A G E N D A
FARRAGUT MUNICIPAL PLANNING COMMISSION

June 20, 2013
7:00 p.m. Farragut Town Hall

**MINUTES
FARRAGUT MUNICIPAL PLANNING COMMISSION**

May 16, 2013

PHOTOMETRIC SITE PLAN	1
Scale = 1/16" = 1'-0"	A-100.2

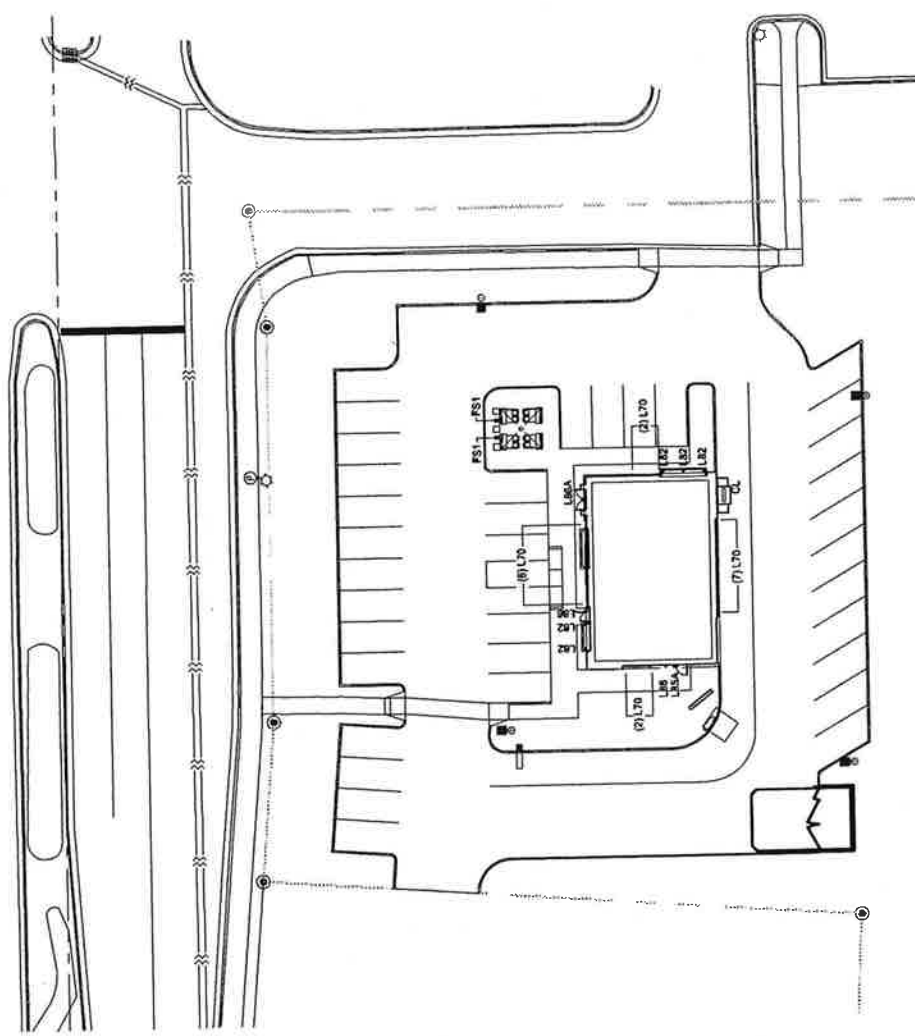
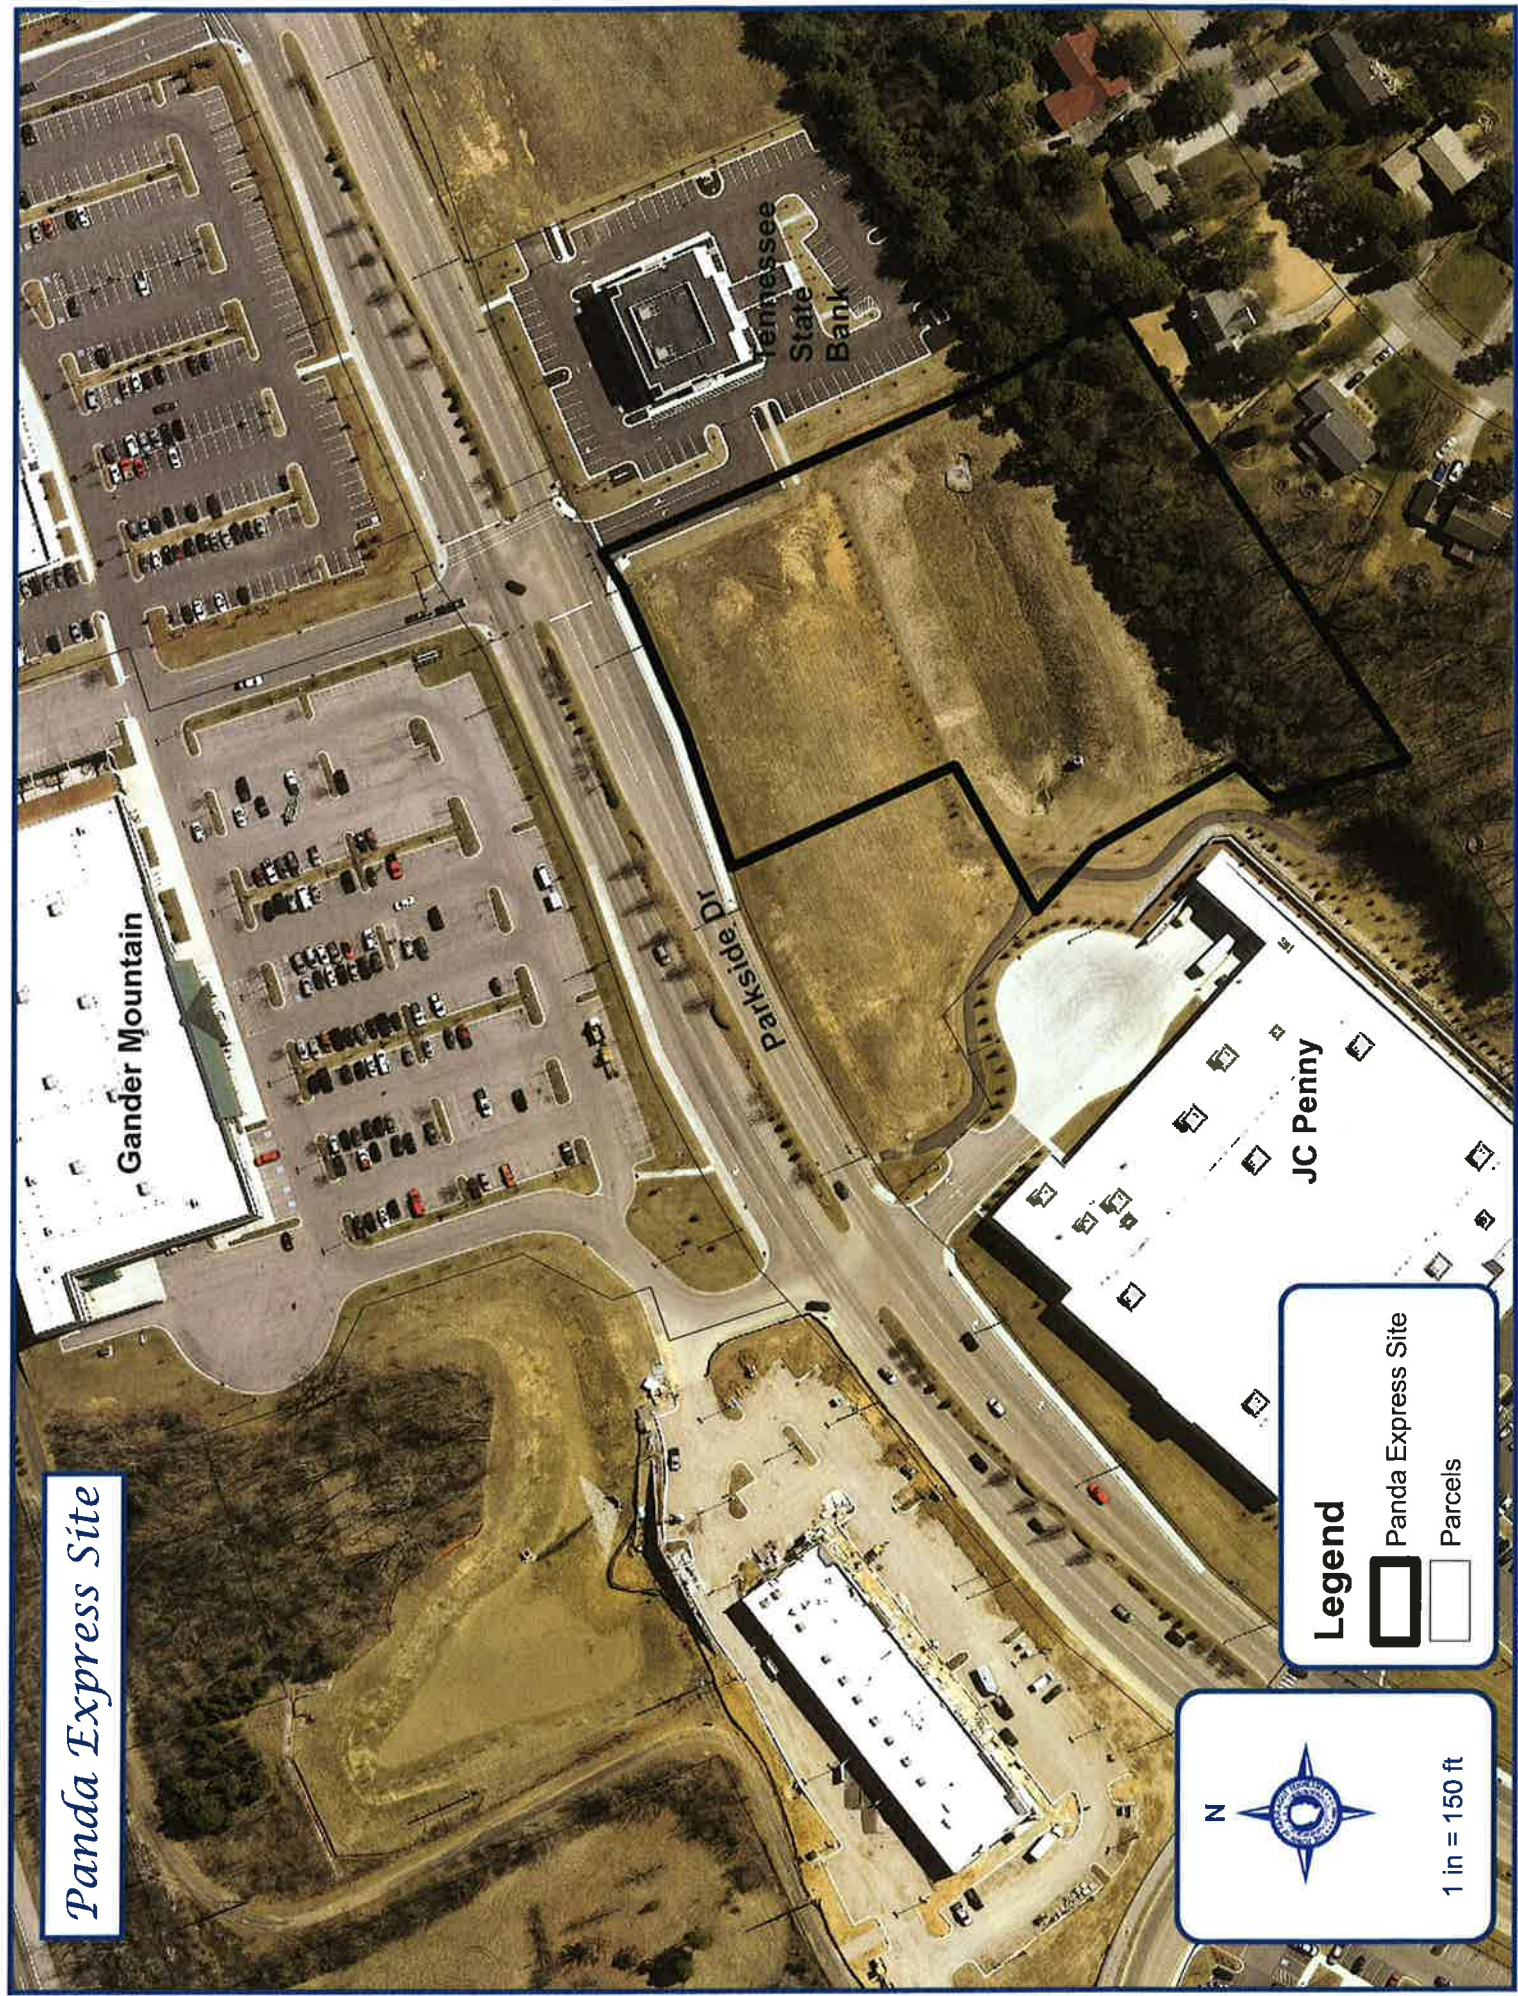
58. How come the footcandles are higher at E-1 and E-2 fixtures?
59. Show details of all proposed light fixtures;

7. Indicate the color of the dumpster enclosure gate;
8. Sheet A-100.2 - Clarify details for fixtures L-82, L-70, CL, FS-1 to insure compliance or replace with compliant fixtures;

FRONT ELEVATION 1

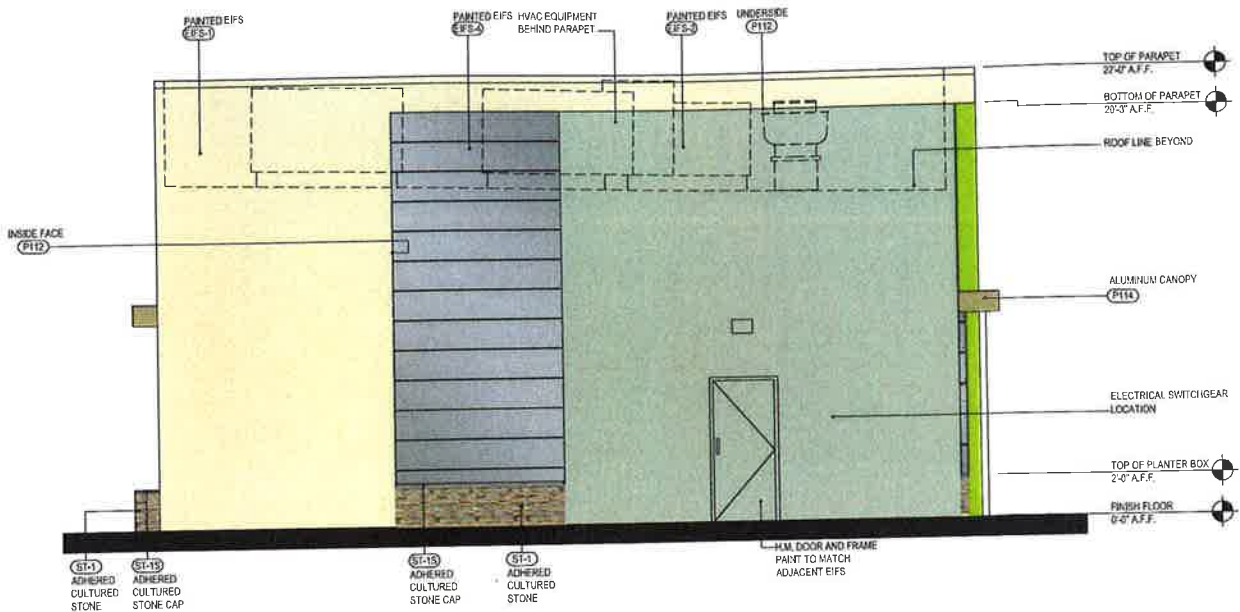
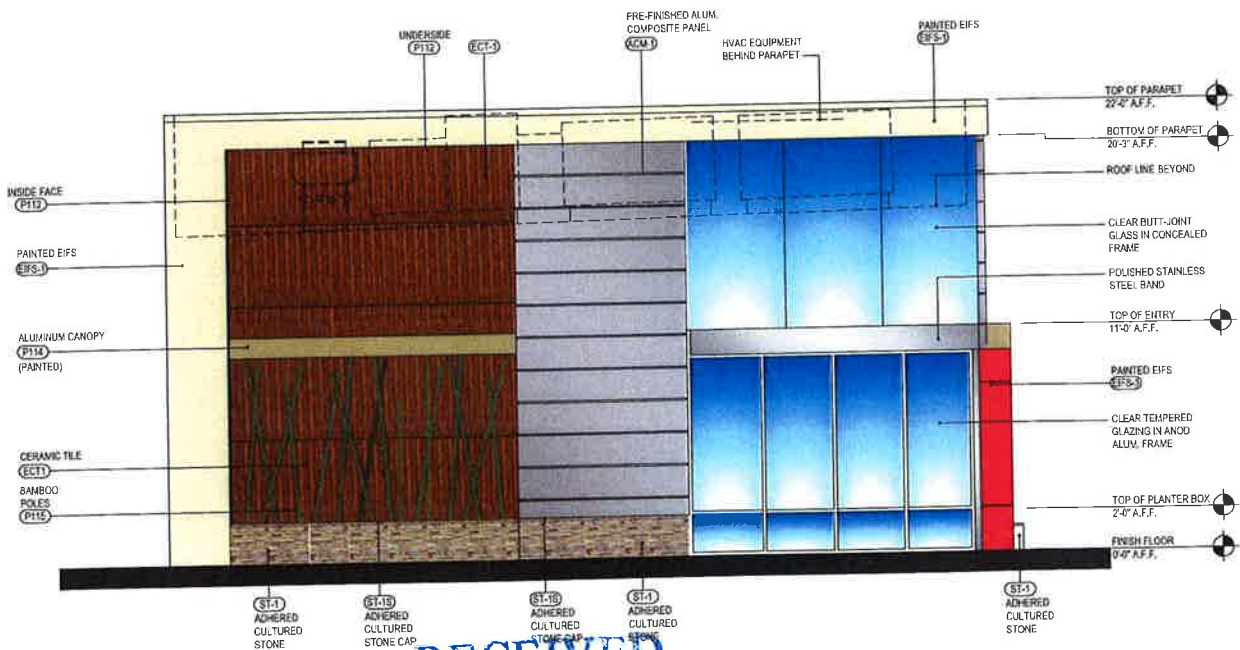
51. **A-200:** Define colors "show stopper, Inverness", "tidewater", "porto plank", etc.
52. The building design does not fit the area. I encourage you to look at the buildings in the vicinity and take these into consideration of proposed design;

53. Clearly identify windows on plans;
54. Include line of sight drawings from adjacent properties and rights-of-way showing that HVAC units are screened by parapet;

ENTRY SIDE ELEVATION

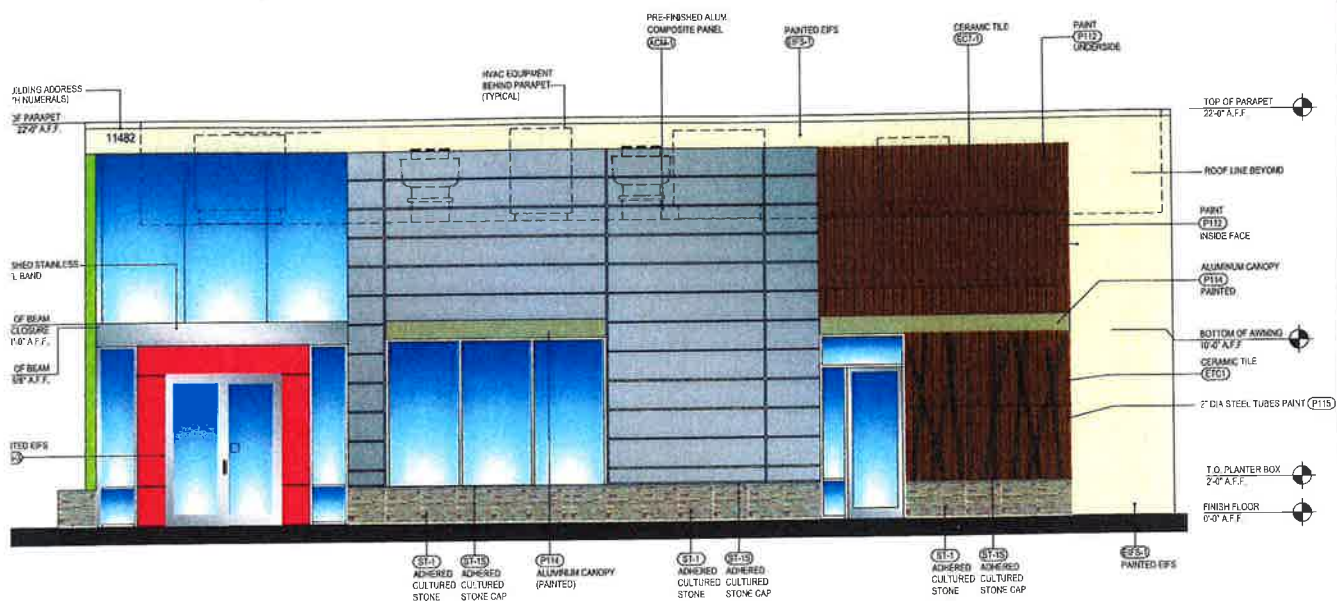
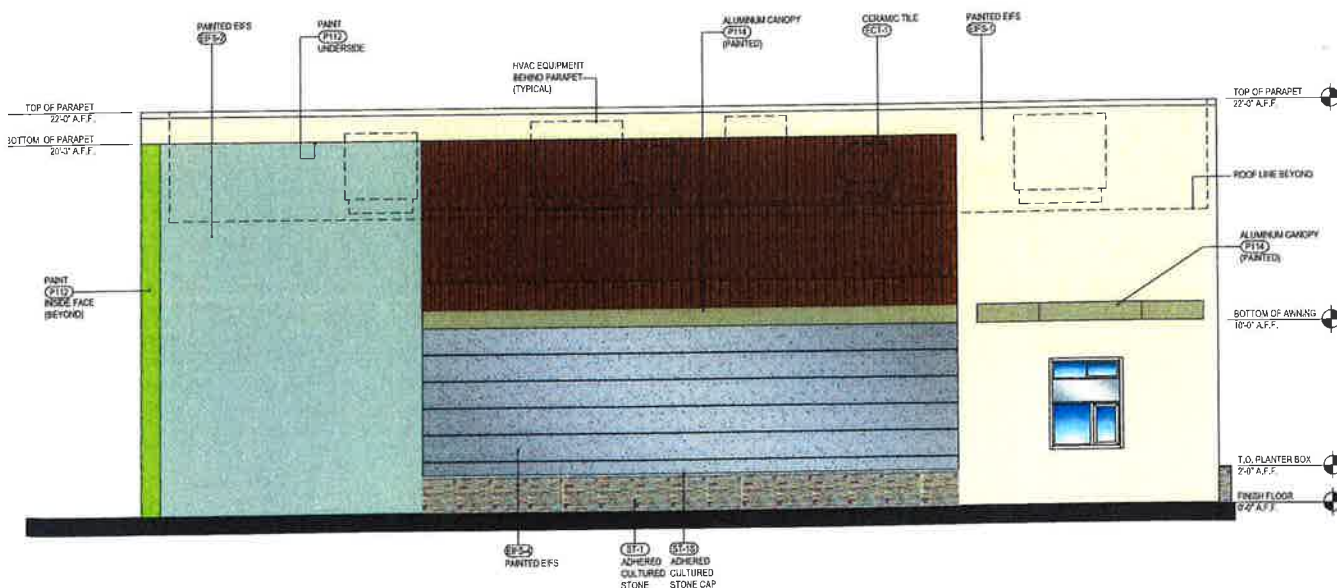
55. **Sheet A-201:** Indicate size of numbers for the building address;
56. Define all building materials;
57. **Sheet A100.1:** Include wall mounted lights and details;

CE.02
SHEET 19 OF 25

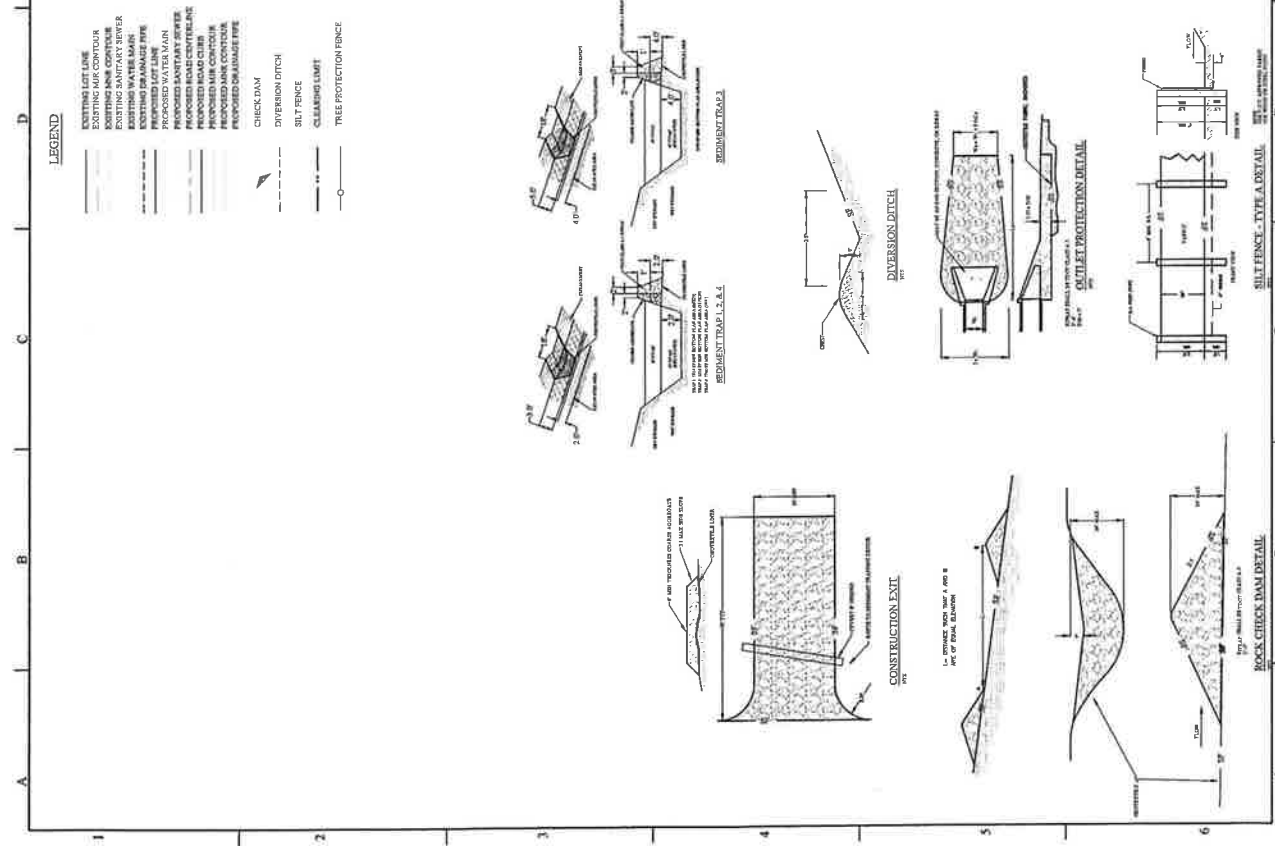
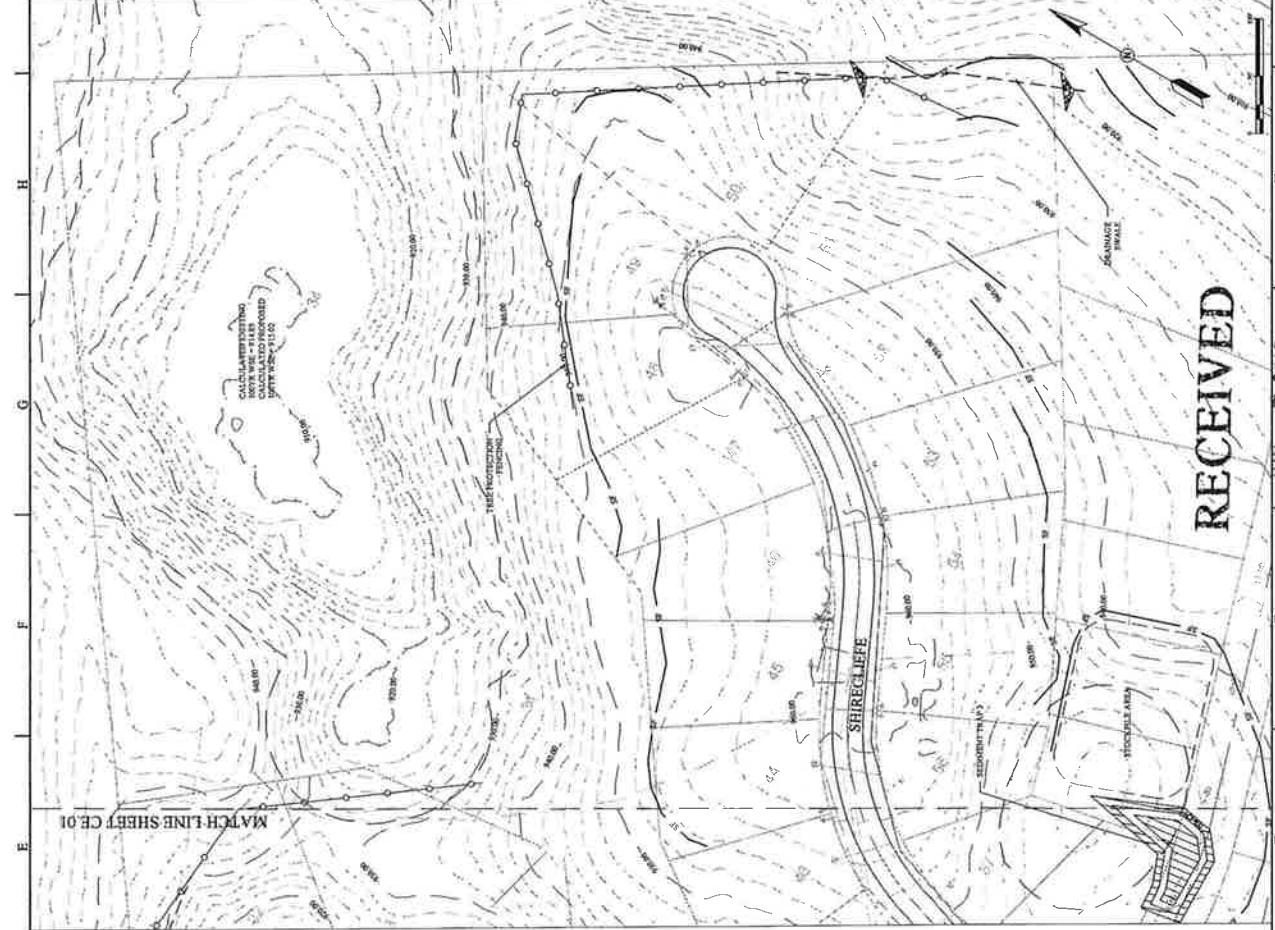
29. Sheet CE.02 - "Area to be returned to existing grade and cover after rock waste mitigation from lots". What is this referring and what is the purpose?
